MODELS AFFECTED: XLU152, XLU1515

ITEM: DESIGN CHANGES TO IMPROVE RADIO PERFORMANCE
IN HIGH SYSTEMS NOISE ENVIRONMENTS

DIAGRAM # 1 VCO BOARD

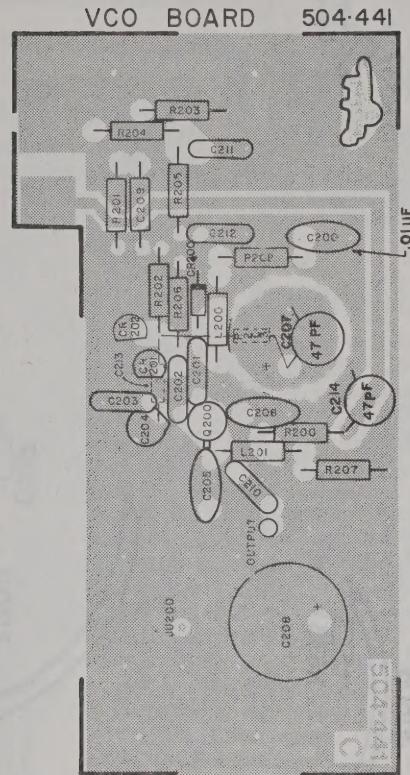
- b. The following caps have been added to the VCO Board (see Diagram #1)

C207 = 47pF (1524-0470-002)

C214 = 47pF (1524-0470-002)

and C200 changed from 150pF to .01μF (1502-0103-004)

DIAGRAM # 3 - PA BOARD

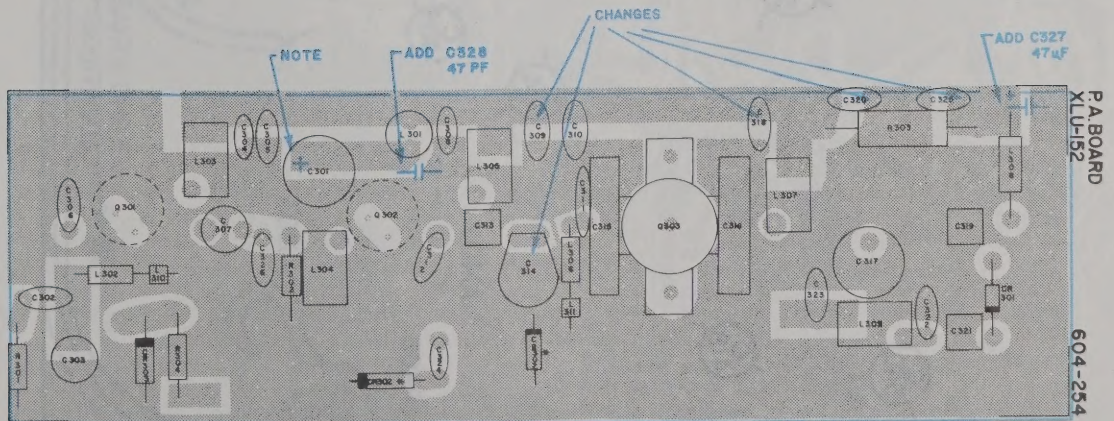
(3) PA Board Modifications (See Diagram #3)

Changed C318 to 1507-0101-002

Changed C325, C320 and C309 to 47pF (1524-0470-002)

Changed C314 to 2-10pF (1517-0000-043)

Added C328 = 47pF (1524-0470-002)

Added C327 = 47μF 16V (1513-0470-002)

It has been ensured that components on PA Board do not have long lead lengths.

DIAGRAM# 2

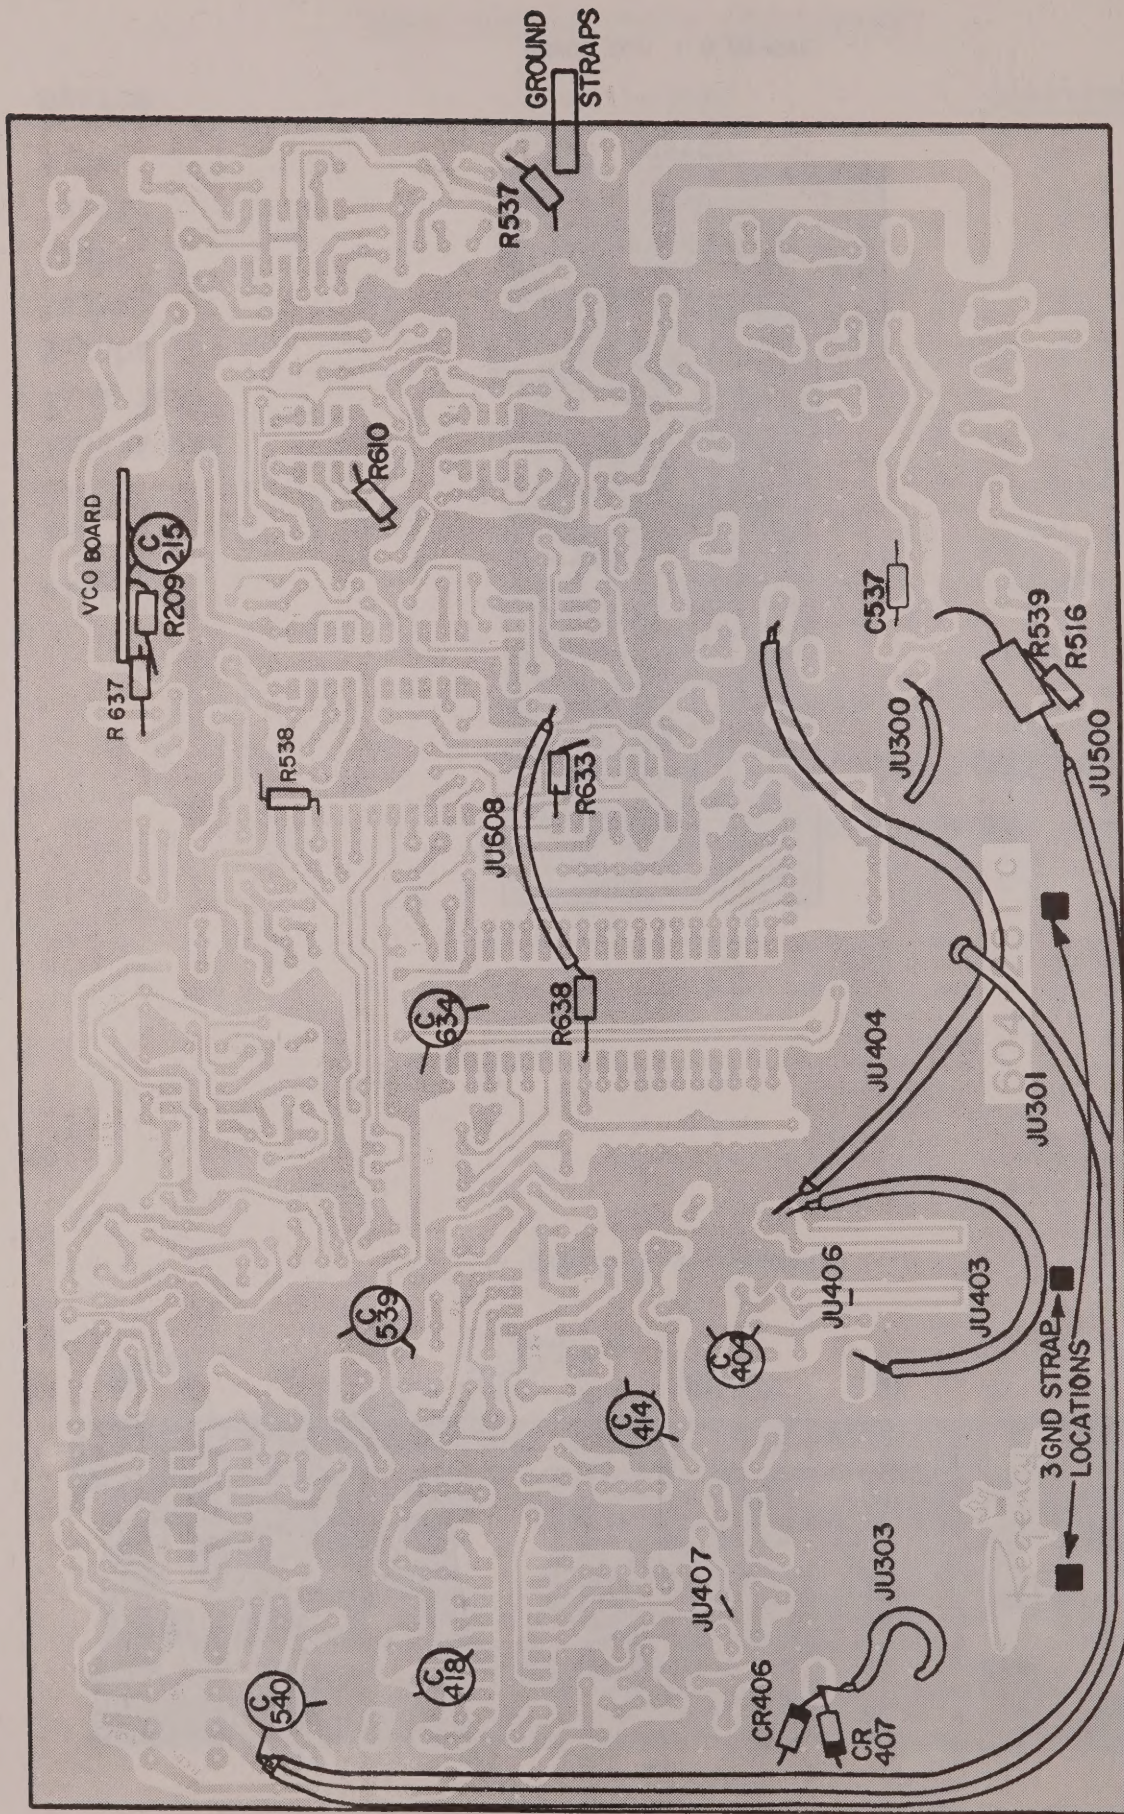
(4) Main Board Modifications (See Diagrams #2 and #6)

Moved C537 to underside of board

Removed R516 = 330Ω

Changed C534 to 150pF (1538-0151-601)

Changed C535 to 47pF (1524-0470-002)

Added R209 = 100Ω (4704-0101-032) in series with 8V supply to VCO Board

Added C215 = 47pF (1524-0470-002)

Added R516 = 220Ω (4704-0221-032) at L501 input to ground on underside

Changed C543 to 1000μF 16V (1513-3254-717) and changed position to across C537

Added ground strap from Main Board to front panel (6011-0000-002)

Re-routed VCO coax and R600 - grounded coax to R606 ground

Added C5 = 47pF (1524-0470-002) from V+ line to chassis at power connector using as short a lead length as possible.

Added ground strap from Main Board to back plate (6001-0000-002)
